## **NSW Roads and Maritime Services**

# **WOOLGOOLGA TO BALLINA | PACIFIC HIGHWAY UPGRADE SUBMISSIONS / PREFERRED INFRASTRUCTURE REPORT**

Chapter 4

November 2013

**Figure 4-28: Revised design at Swan Bay New Italy Road**

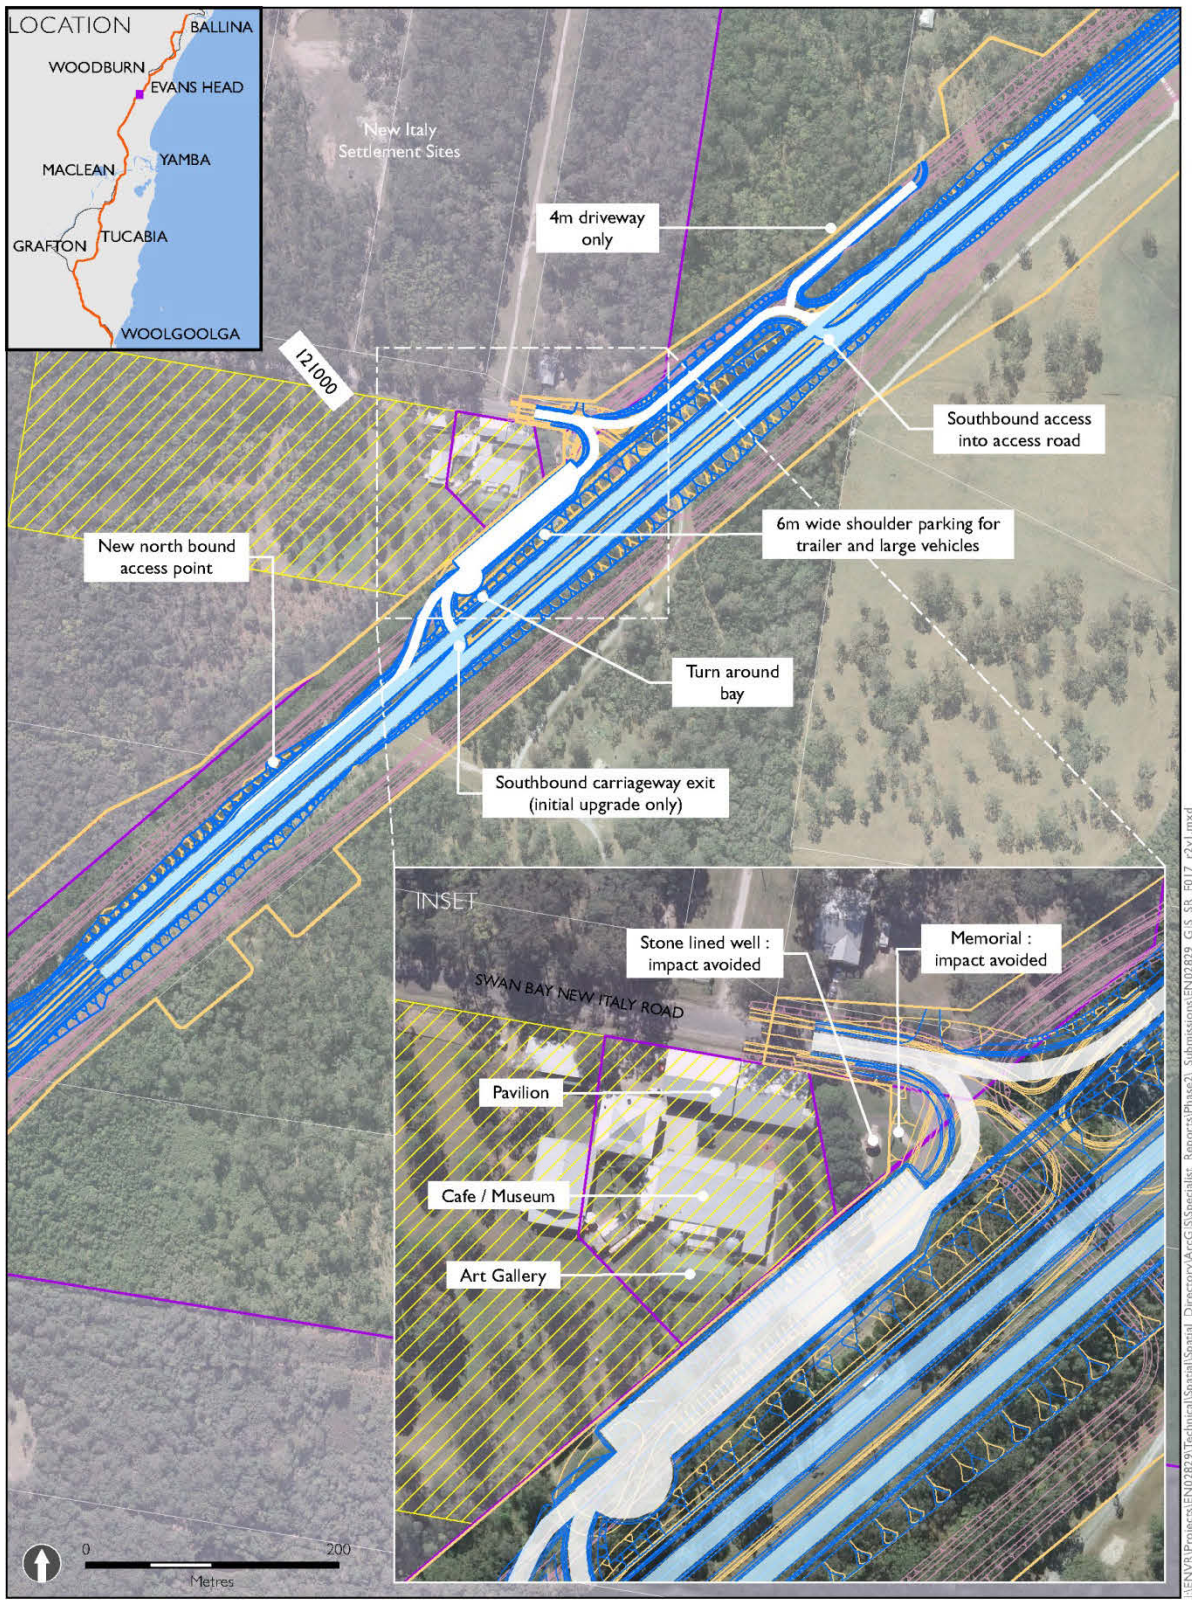
The design refinement shown in Figure 4-28 consists of:

- Two half left-in intersections to access Swan Bay New Italy Road, 200 metres either side of the existing intersection.
- A left-in auxiliary lane and slip road to the south to enable traffic from the northbound carriageway to enter Swan Bay New Italy Road. The access road to the north would also provide access to the northbound highway carriageway via a left-out only intersection.

- A median right-turn lane in the form of a half seagull intersection to enable southbound vehicles to access Swan Bay New Italy Road.
- An overpass at station 121.5 to connect Swan Bay New Italy Road to the eastern service road. The median turn lanes would be removed to prevent access to Swan Bay New Italy Road from the southbound carriageway. The left-in and left-out only intersections would remain as part of the motorway upgrade. This would provide direct access to the New Italy Settlement and Swan Bay New Italy Road for the northbound carriageway only.

Under the design refinement, the design of the intersection of Swan Bay New Italy Road and the proposed highway upgrade would be modified to improve the vertical alignment of the intersection and reduce the impact on a historic heritage item in the New Italy Settlement (Museum Complex, State Heritage Register 1648, Richmond Valley Local Environmental Plan 2012, ID I148).

**Figure 4-29: Revised borrow site at Lang Hill**

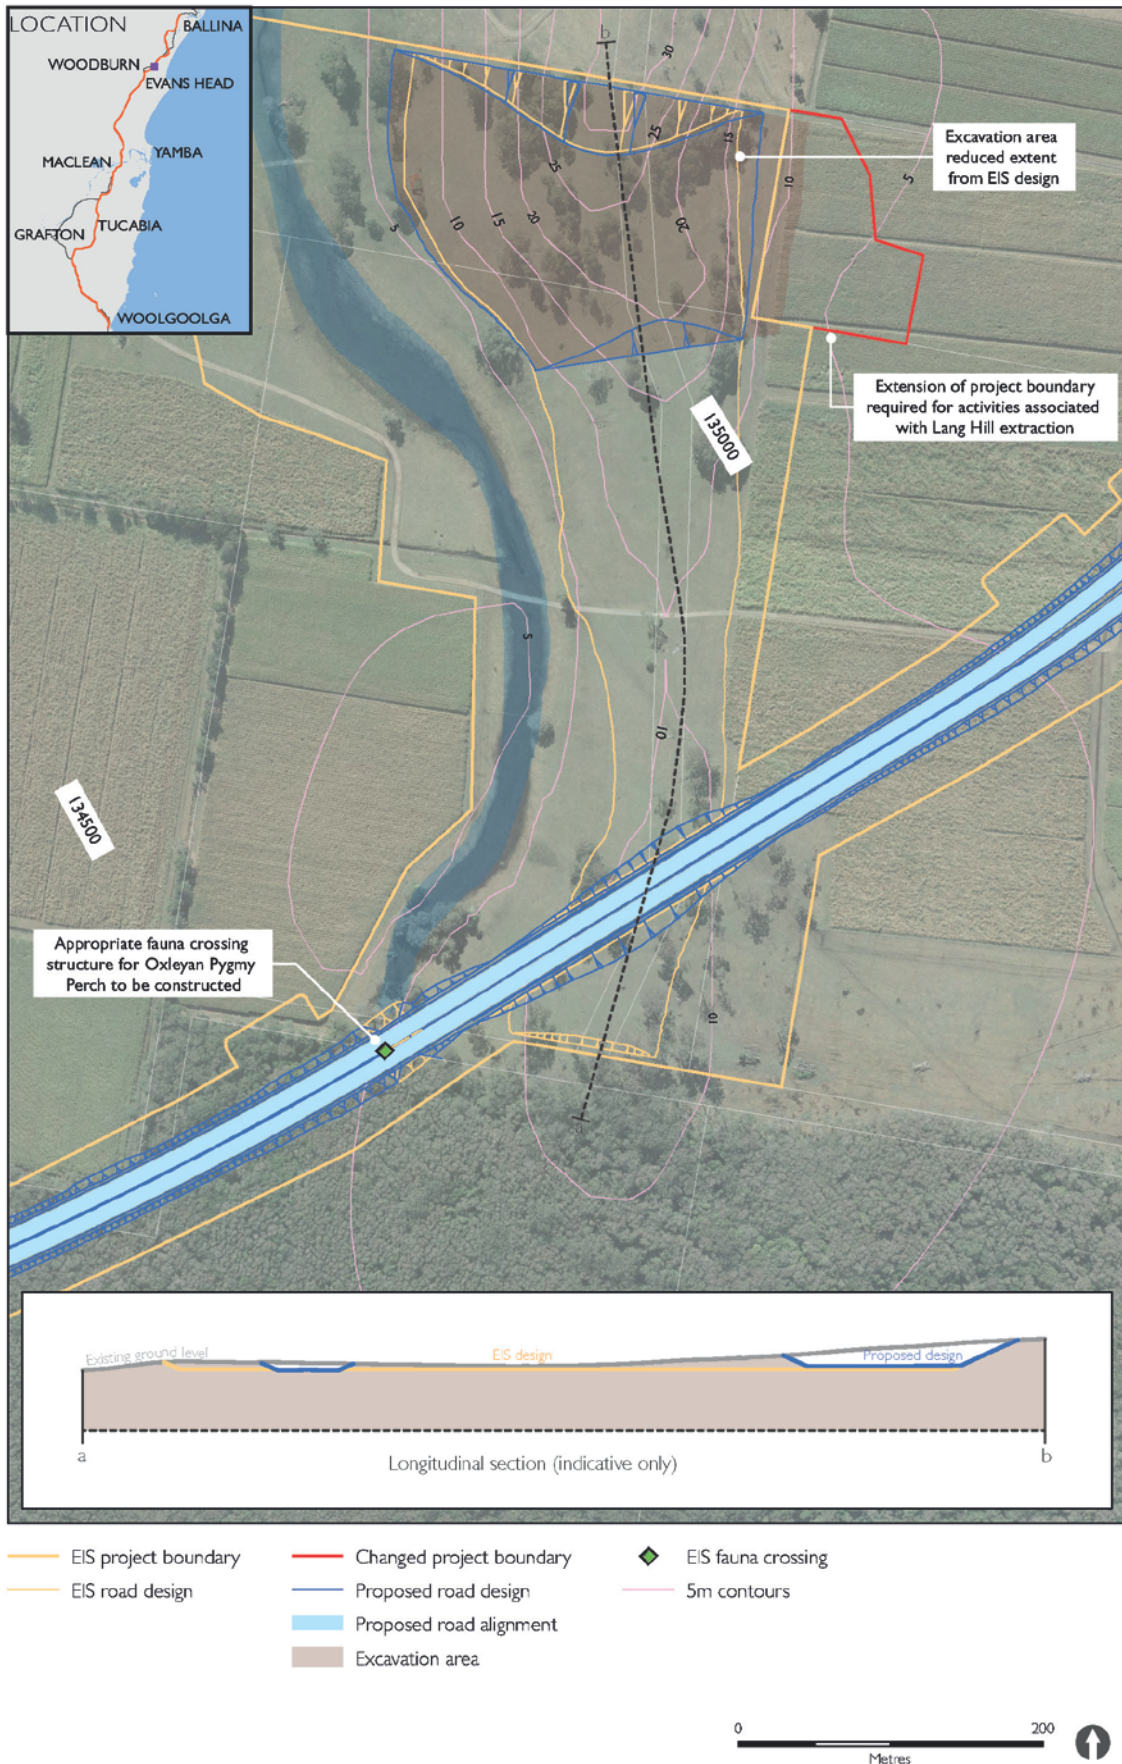
Figure 4-29 shows the design refinement at this location. The use of Lang Hill as a borrow site was reviewed to reduce the extent of cutting and impact on the site, reducing the material excavated by around one-third. The refined area of the borrow site would be located around 250 metres to the north of the project (for further details, refer to the Lang Hill Environmental Work Method Statement (Appendix G of this report)).

By reducing the area of the borrow site from the design in the EIS, the new design would restrict ground disturbance works to the northern end of the site (Figure 4-29). This would be a significant reduction in area and minimise the potential impact on known habitat for Oxleyan Pygmy Perch to the west of the site.

**Figure 4-31: Overview of rest areas north of Richmond River**

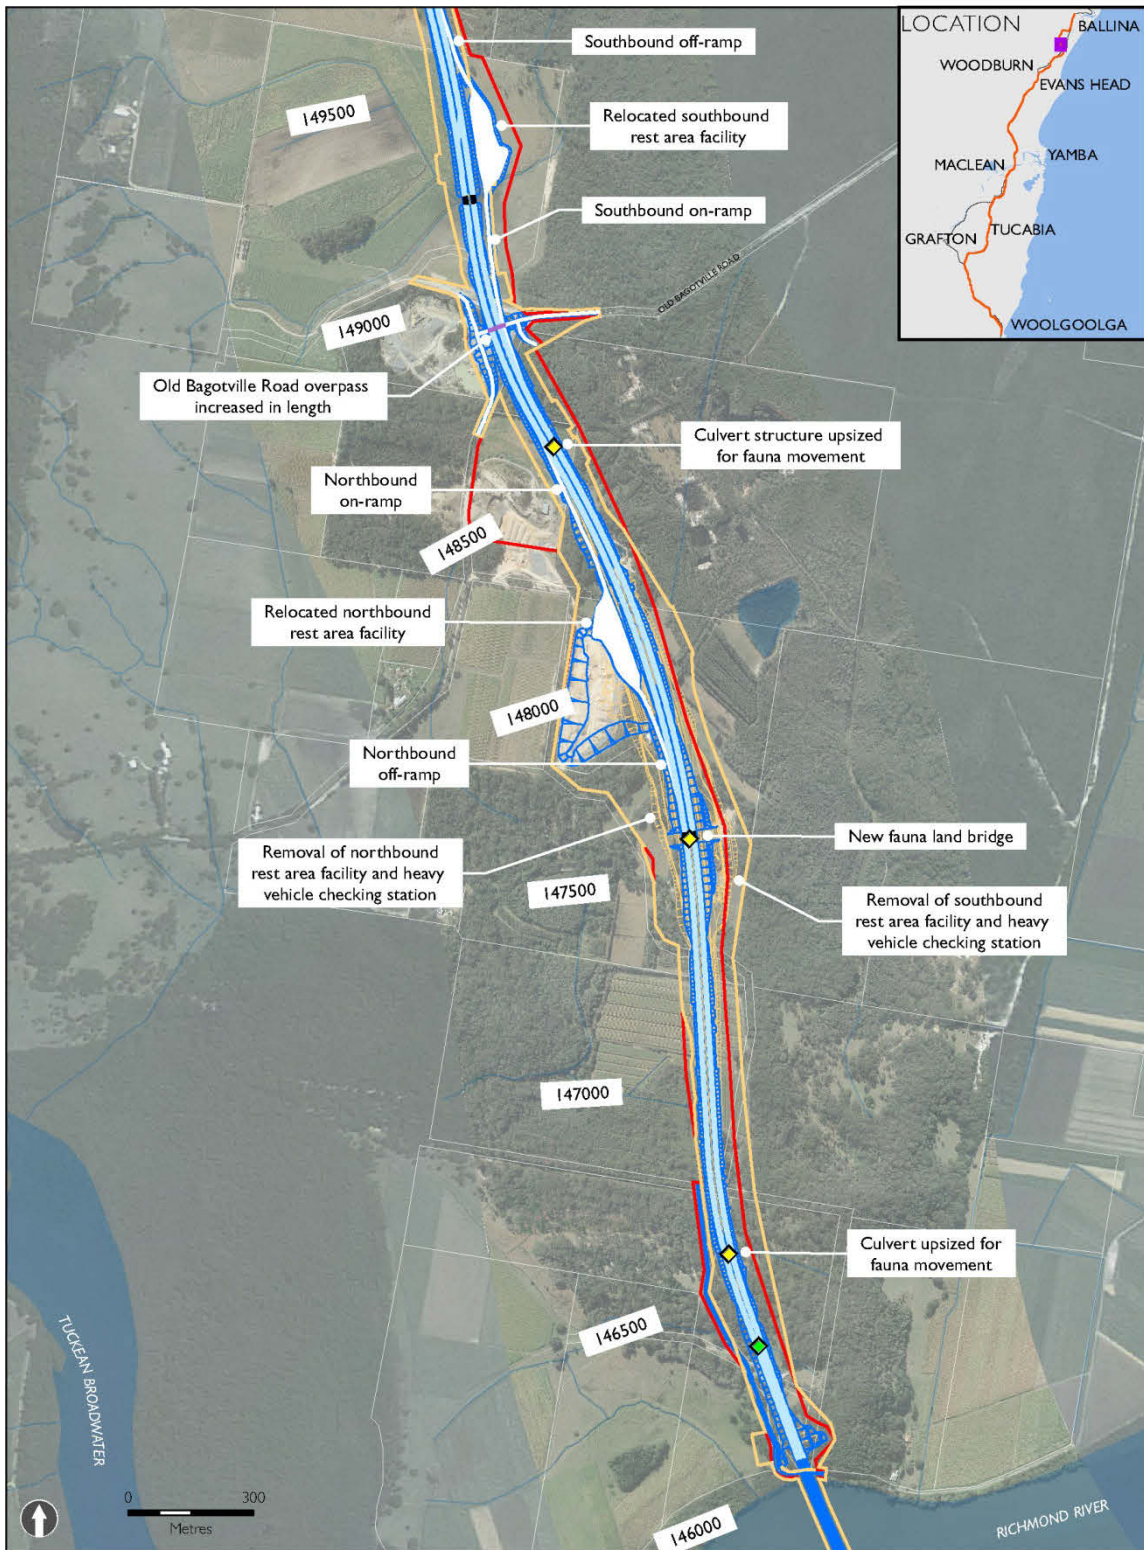
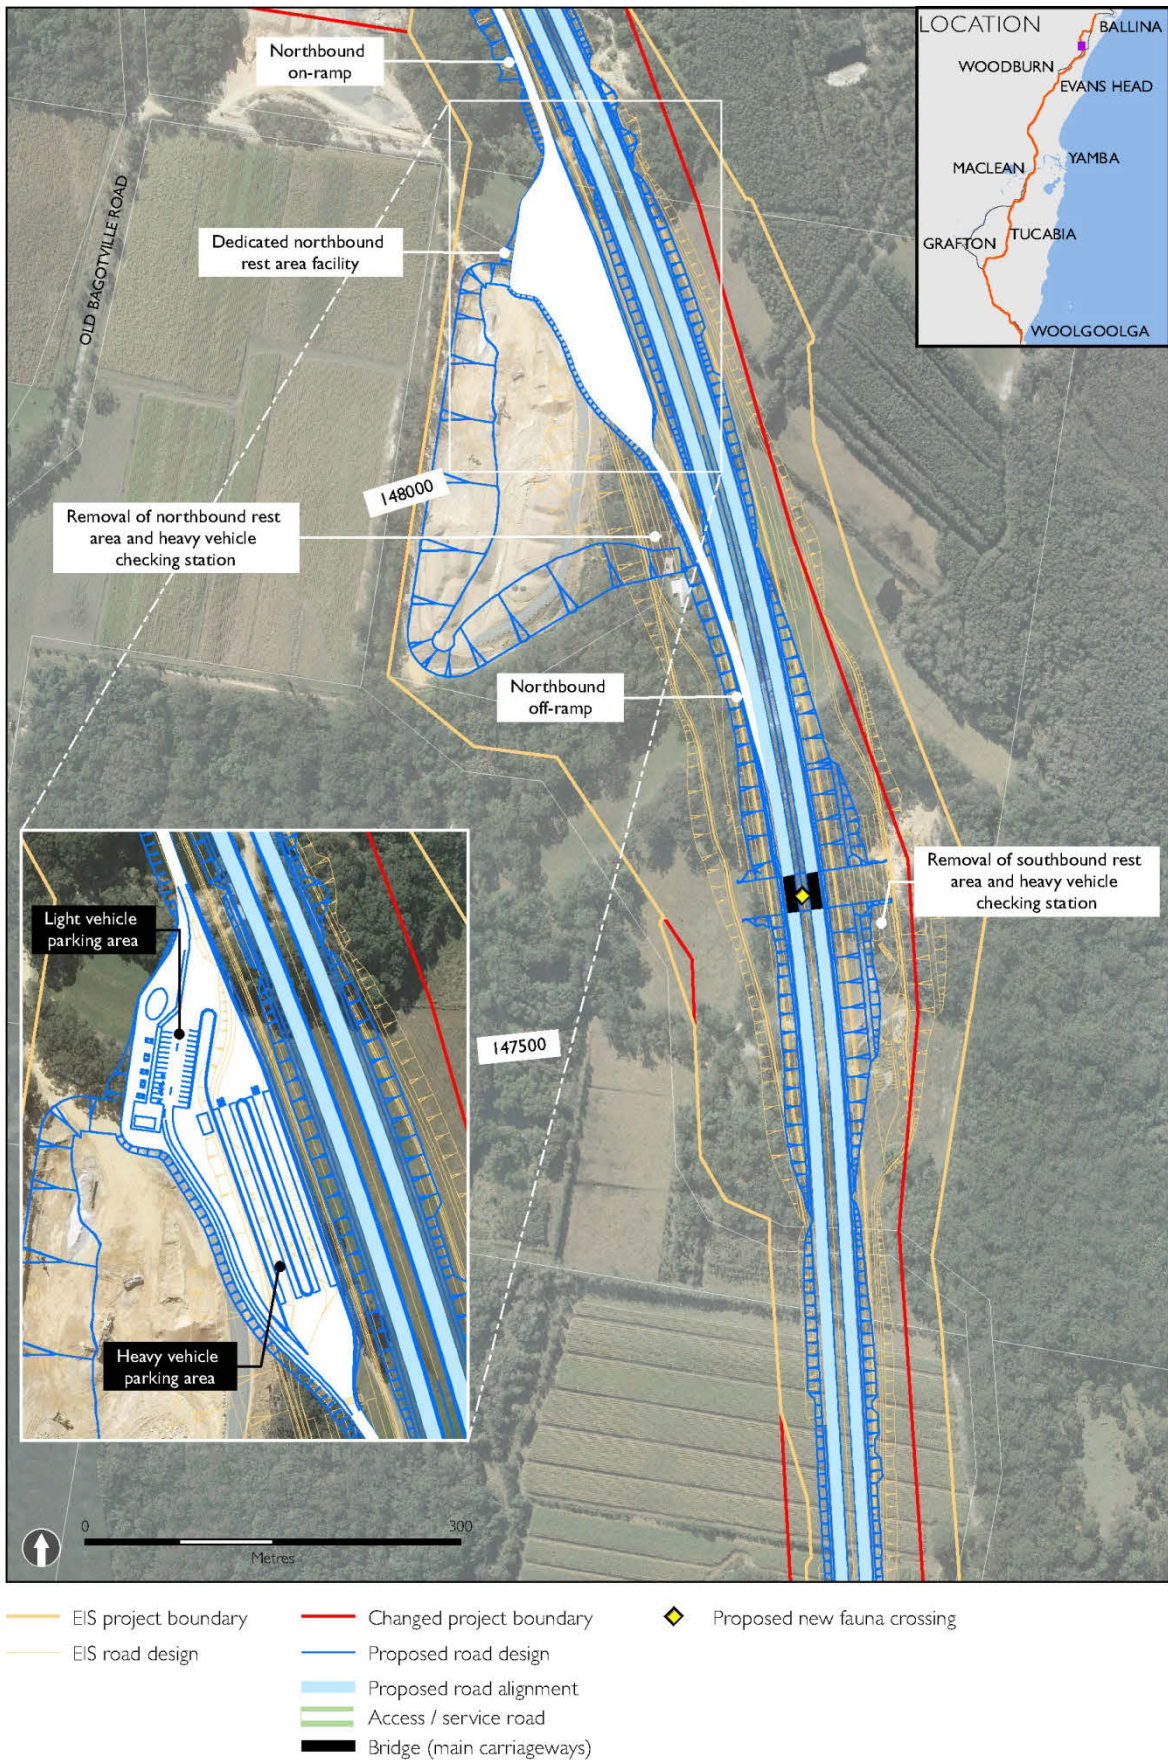
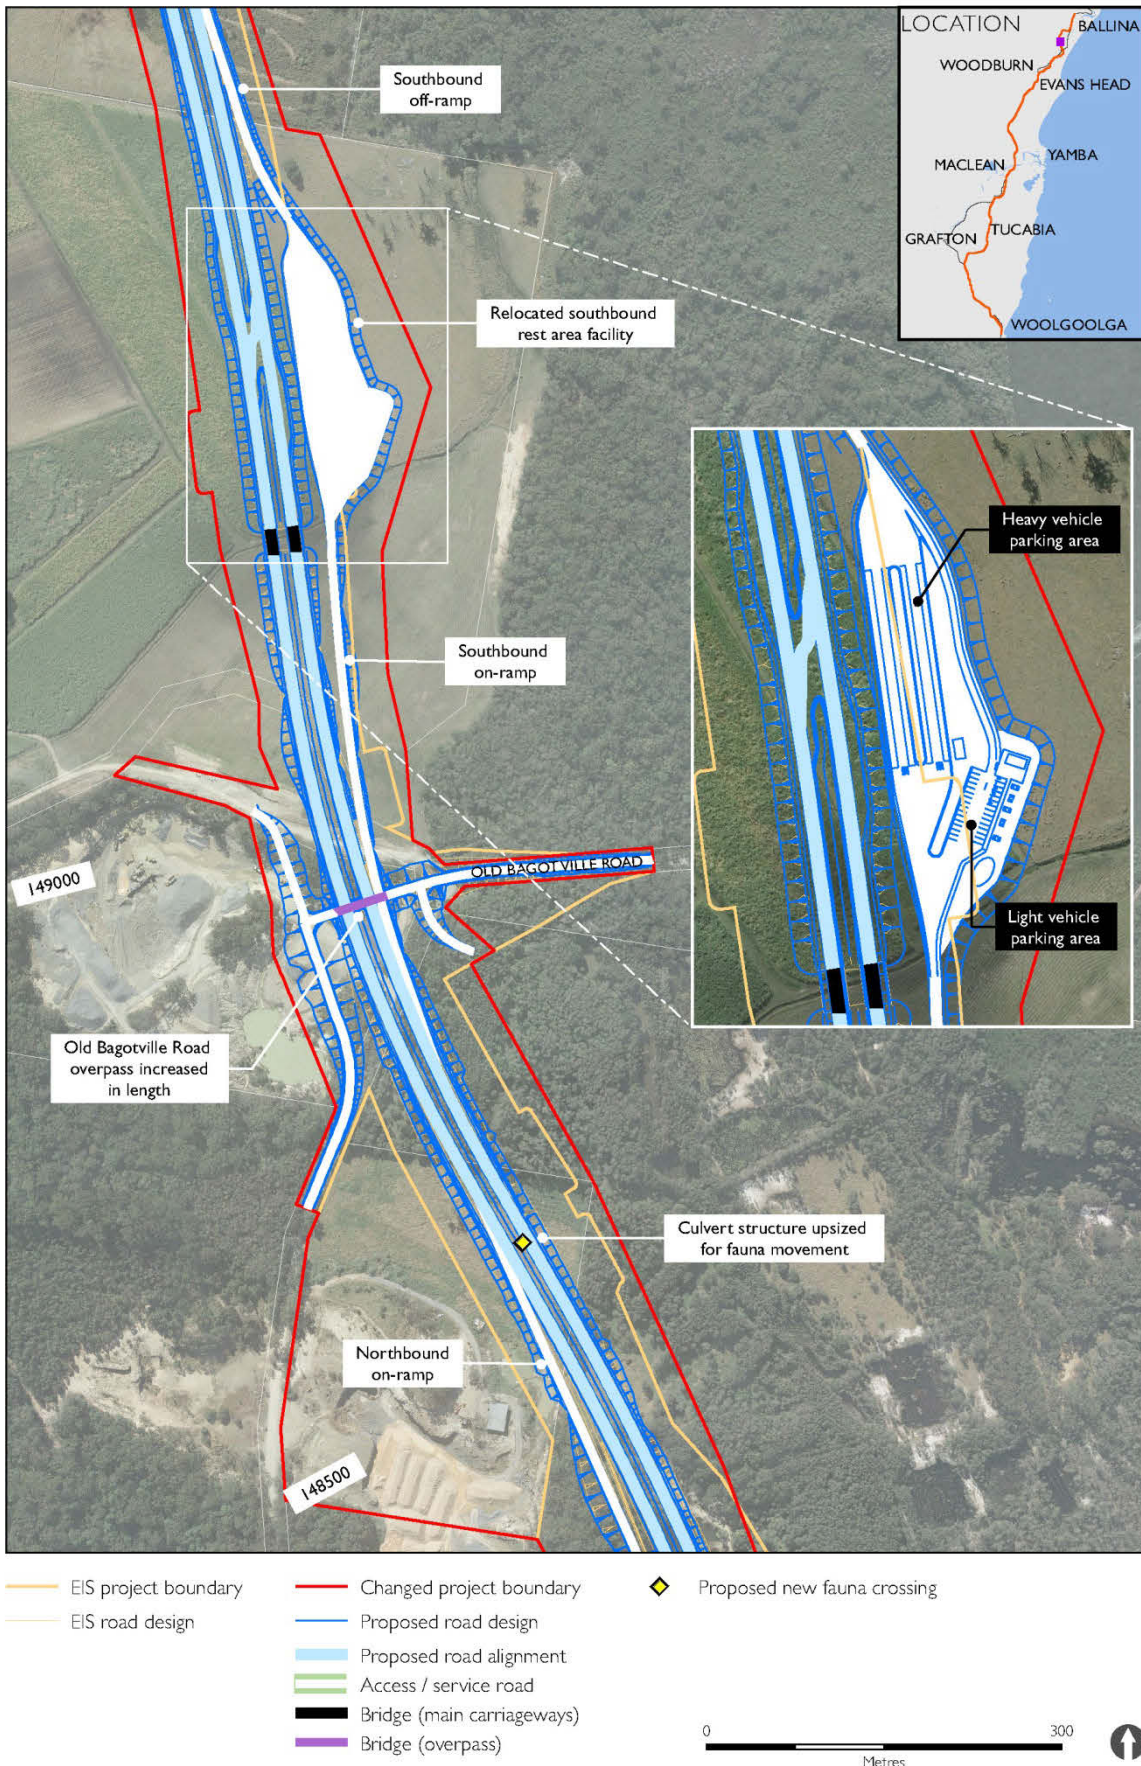
The design refinement is shown in Figure 4-31 to Figure 4-33.

The preferred rest area location would be east of the Eatons borrow site for the northbound rest area and north of Old Bagotville Road for the southbound rest area. This location would reduce the need for vegetation clearing and minimise the area of additional land to be acquired.
